**2019 CMOM PACKAGE 2 (URGENT)**

**Solicitation Number: CO-00333**

**Job No.: 19-4533**

**ADDENDUM 2**

SHEET 10 OF 39

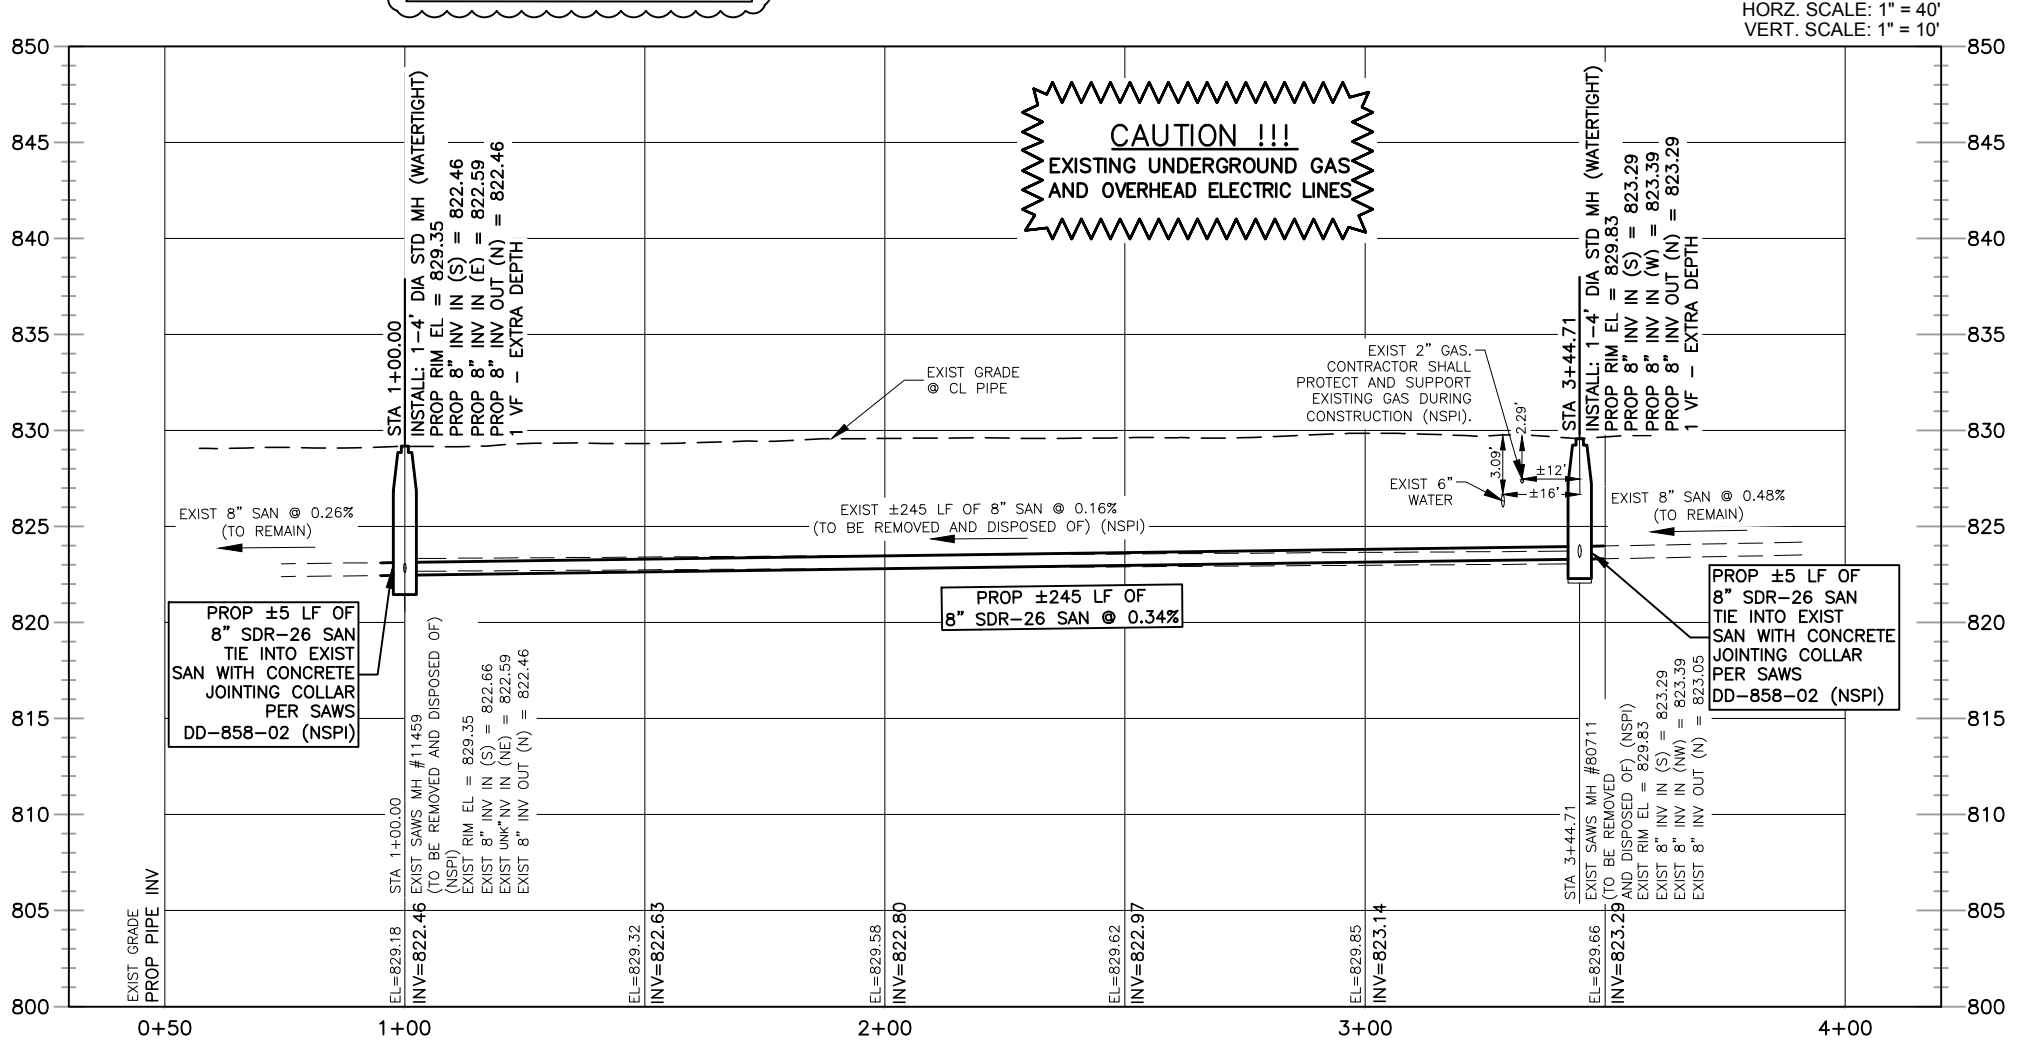
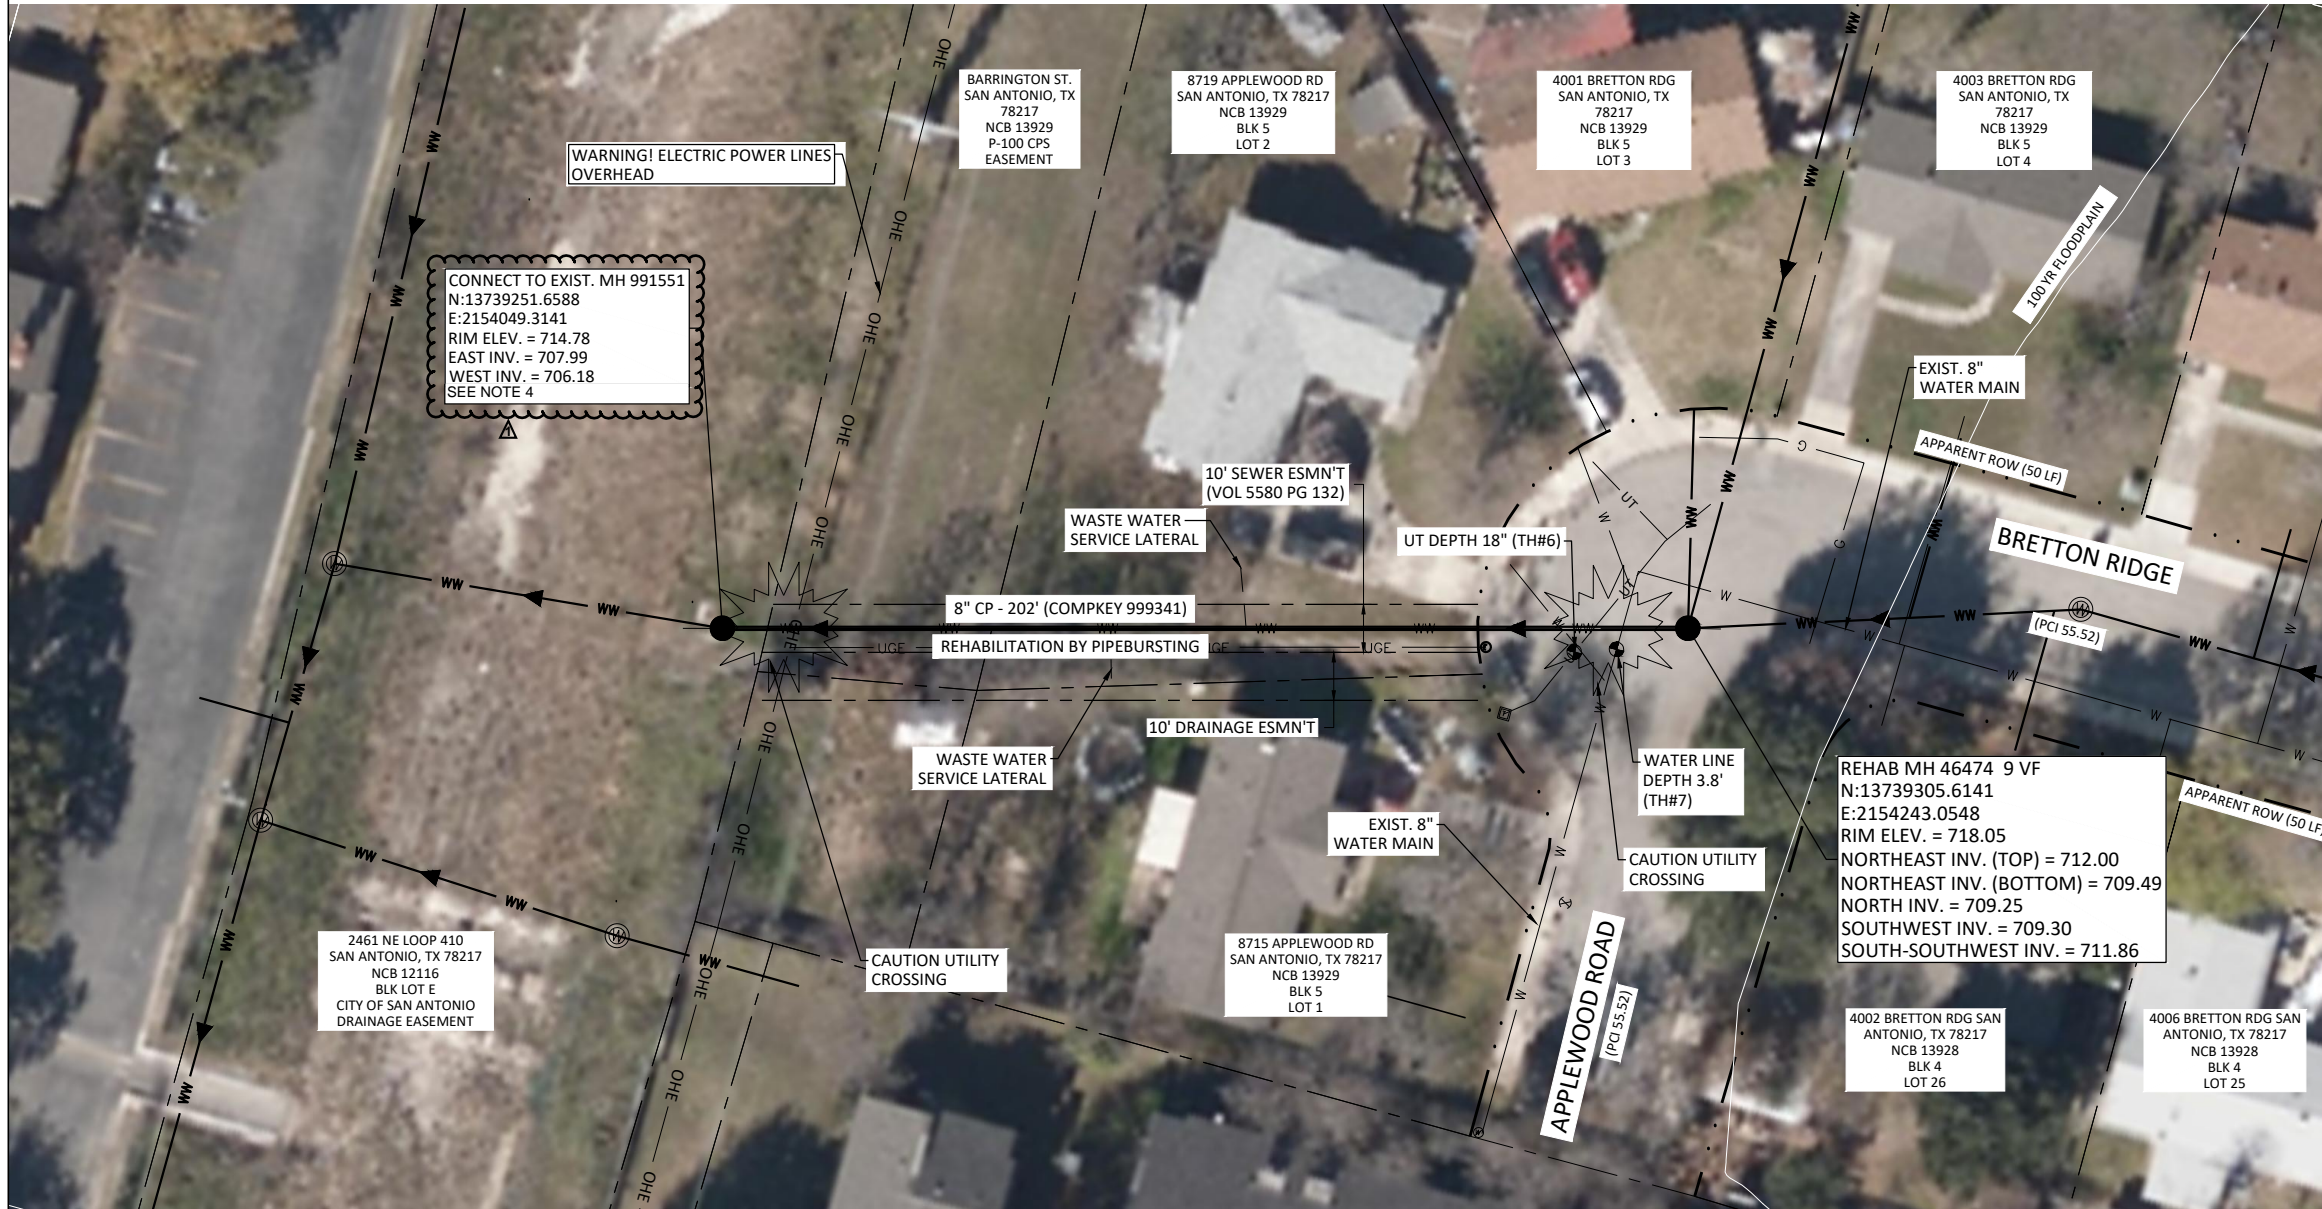
4. Sheet 10: Remove and replace with the attached sheet within this Addendum. The following updates have been made:
  - a. Existing AT&T Cable Linework and crossing callout have been **added**.

- b. Callout **added**: PRIOR TO EXCAVATION/ REMOVAL OF EXISTING MANHOLES, AND INSTALLATION OF PROPOSED MANHOLES CONTRACTOR SHALL VERIFY EXACT LOCATION AND DEPTH OF EXISTING UTILITIES. CONTRACTOR SHALL PROTECT AND SUPPORT EXISTING UTILITIES DURING CONSTRUCTION (NSPI)

- c. Callout **added**: EXISTING VOID AND UTILITY IN THIS AREA. CONTRACTOR SHALL PROTECT, MAINTAIN, SUPPORT EXISTING UTILITIES DURING CONSTRUCTION (NSPI). CONTRACTOR TO BACKFILL THE VOID WITH FLOWABLE FILL TO SUPPORT EXISTING UTILITIES IN THIS AREA.

- d. Item 413.1 Flowable Fill (CoSA Spec) 4 CY **added**.
5. Sheet 13: Remove and replace with the attached sheet within this Addendum. The following updates have been made:

- 1. Sheet 10: Contractor is to be aware of the existing void and AT&T utility found 73.8 LF upstream of MH 11459 on Broadway St. Contractor shall protect maintain, support existing utilities during construction and notify the engineer of any conflicts in this area (NSPI). Contractor is to backfill the void with flowable fill to support existing utilities in this area.

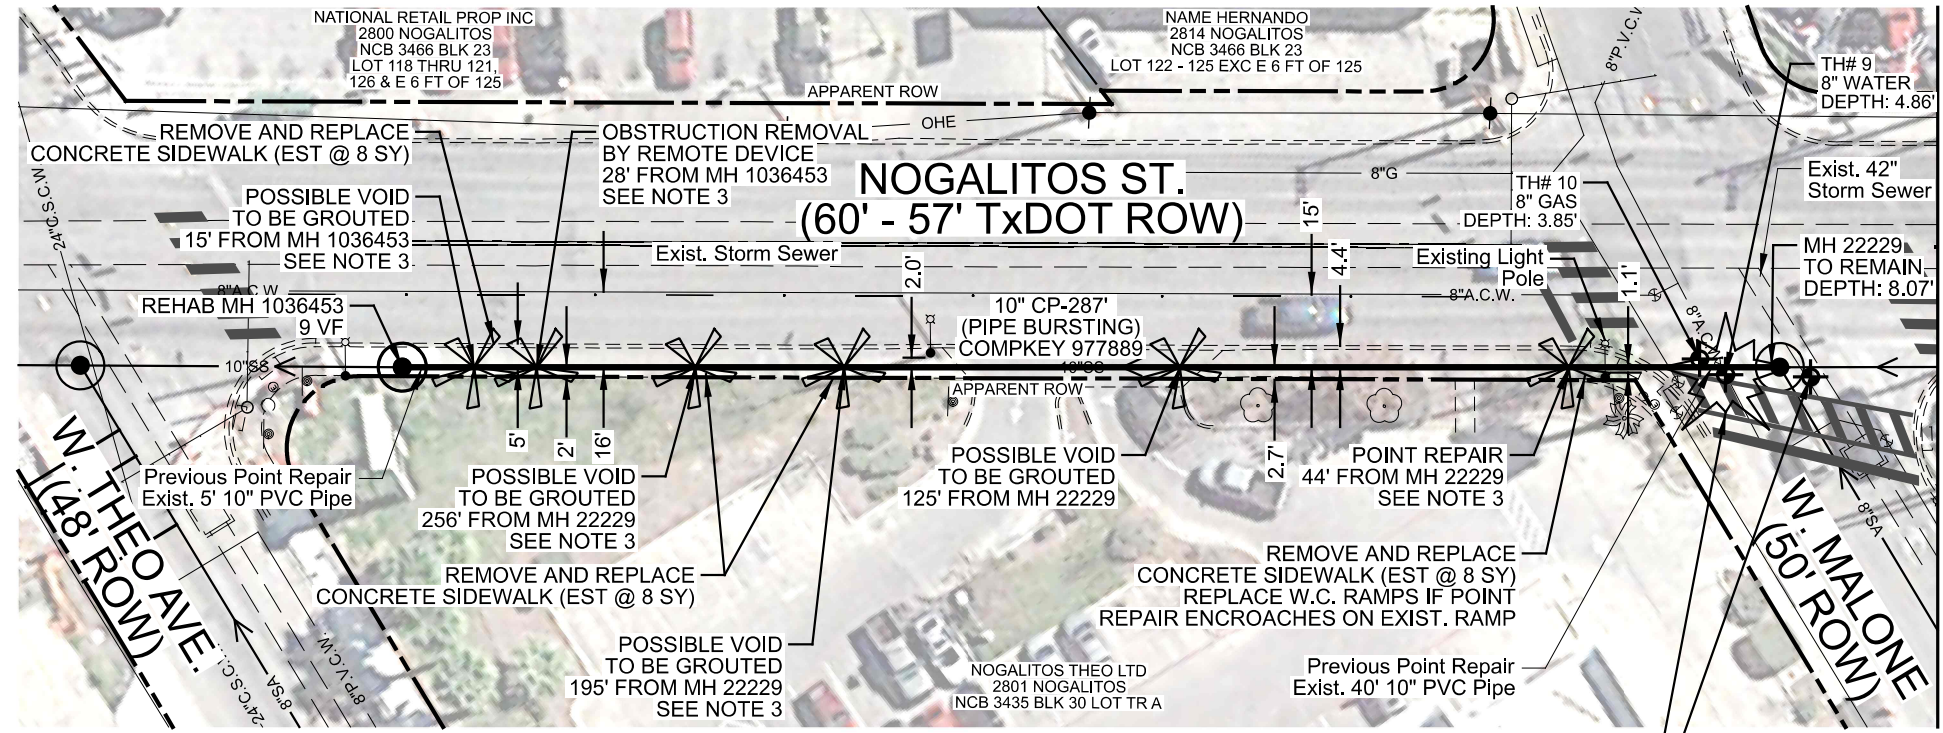
- a. The following note was **added**: CONTRACTOR TO VERIFY THE CONDITION OF MANHOLE 991551 AND CONFIRM WITH INSPECTOR IF THE MANHOLE REQUIRES TO BE ADJUSTED PER SAWS STANDARD SPECIFICATION NO. 851.

- b. 8" DR 13.5 160 PSI Sanitary Sewer Pipe to be installed.
    - i. Bid Item 900 Pipe Bursting 8" Sanitary Sewer Pipe 0'-10' depth (DR 13.5 160 PSI) has been **added**.

- ii. Bid Item 900 Pipe Bursting 8" Sanitary Sewer Pipe 0'-10' depth has been **removed**.
6. Sheet 14: Remove and replace with the attached sheet within this Addendum. The following updates have been made:

2019 CMOM PACKAGE 2 (URGENT)  
**NOGALITOS ST. SAN. SEWER LAYOUT SHEET 1 OF 2**

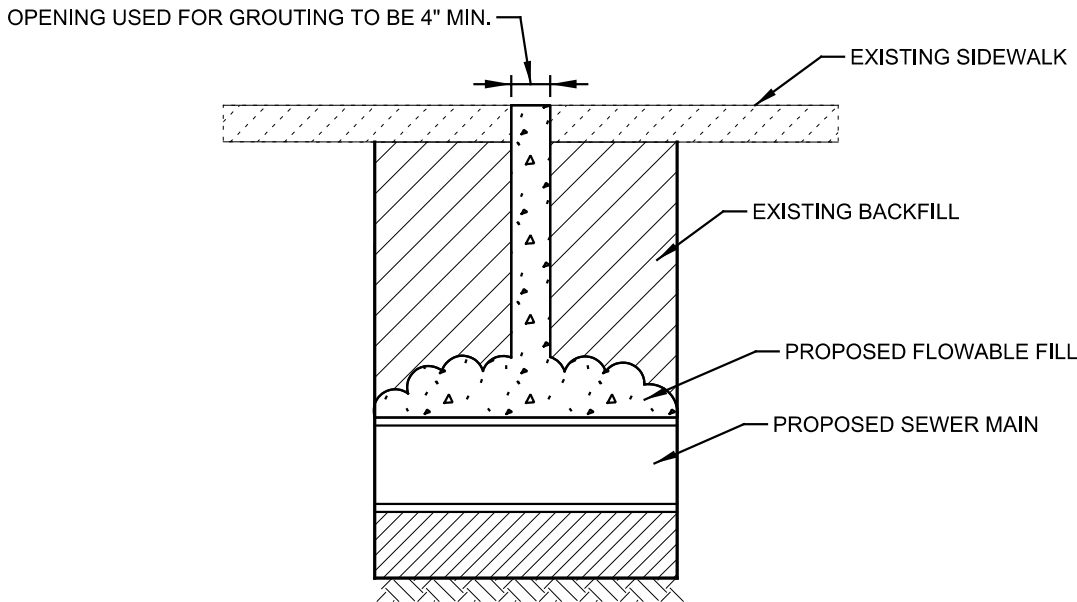
- a. Callouts and quantities for the removal and replacement of driveway have been **removed**. Driveway to remain in place.
  - b. The following notes were **added**:

- i. CONTRACTOR TO AVOID SETTING PIPEBURSTING PITS WITHIN DRIVEWAYS AND STREET INTERSECTIONS.
    - ii. CONTRACTOR SHALL COMPLETE ALL WORK DURING NIGHT HOURS AS APPROVED BY TXDOT AND SAWS.

- c. 10" DR 13.5 160 PSI Sanitary Sewer Pipe to be installed.
    - i. Bid Item 900 Pipe Bursting 10" Sanitary Sewer Pipe 0'-10' depth (DR 13.5 160 PSI) has been **added**.

- ii. Bid Item 900 Pipe Bursting 10" Sanitary Sewer Pipe 0'-10' depth has been **removed**.
7. Sheet 15: Remove and replace with the attached sheet within this Addendum. The following updates have been made:

2019 CMOM PACKAGE 2 (URGENT)  
**NOGALITOS ST. SAN. SEWER LAYOUT SHEET 2 OF 2**

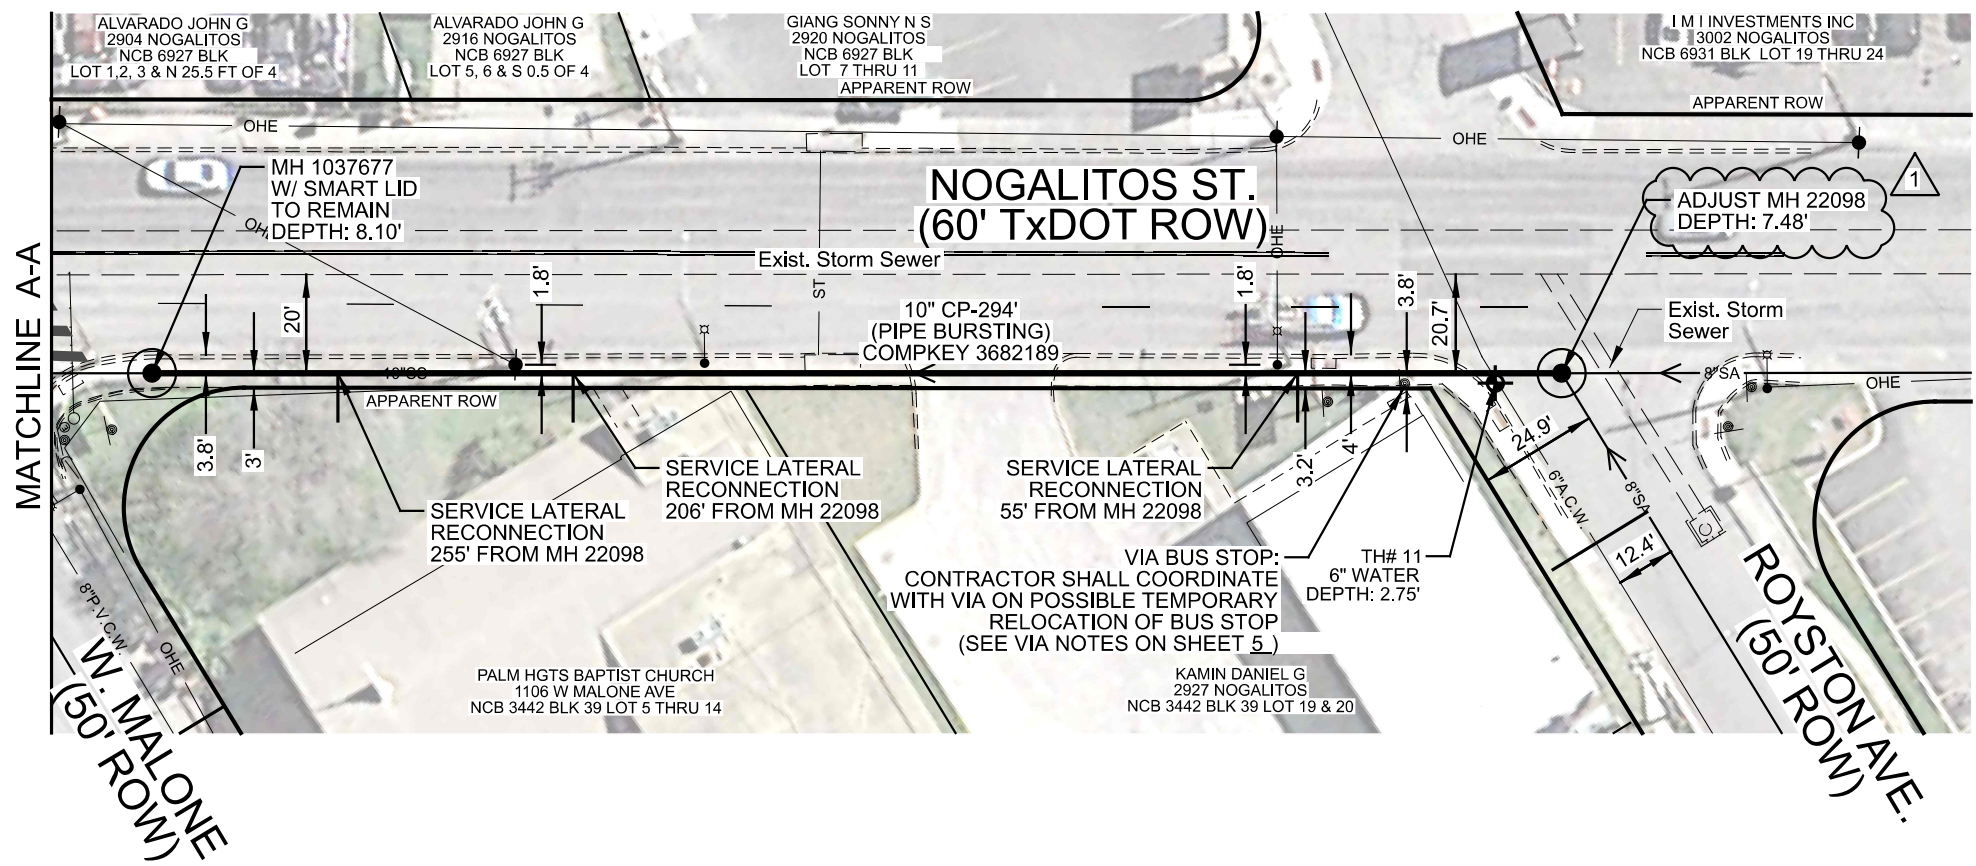
- a. The following note was **added**:
    - i. CONTRACTOR TO AVOID SETTING PIPEBURSTING PITS WITHIN DRIVEWAYS AND STREET INTERSECTIONS.
    - ii. CONTRACTOR SHALL COMPLETE ALL WORK DURING NIGHT HOURS AS APPROVED BY TXDOT AND SAWS.

- b. 8" DR 13.5 160 PSI Sanitary Sewer Pipe to be installed.
    - i. Bid Item 900 Pipe Bursting 10" Sanitary Sewer Pipe 0'-10' depth (DR 13.5 160 PSI) has been **added**.

- ii. Bid Item 900 Pipe Bursting 10" Sanitary Sewer Pipe 0'-10' depth has been **removed**.
  - c. Bid Item 851 Adjusting Existing Manholes (with new ring & cover) has been **added** for MH 22098.
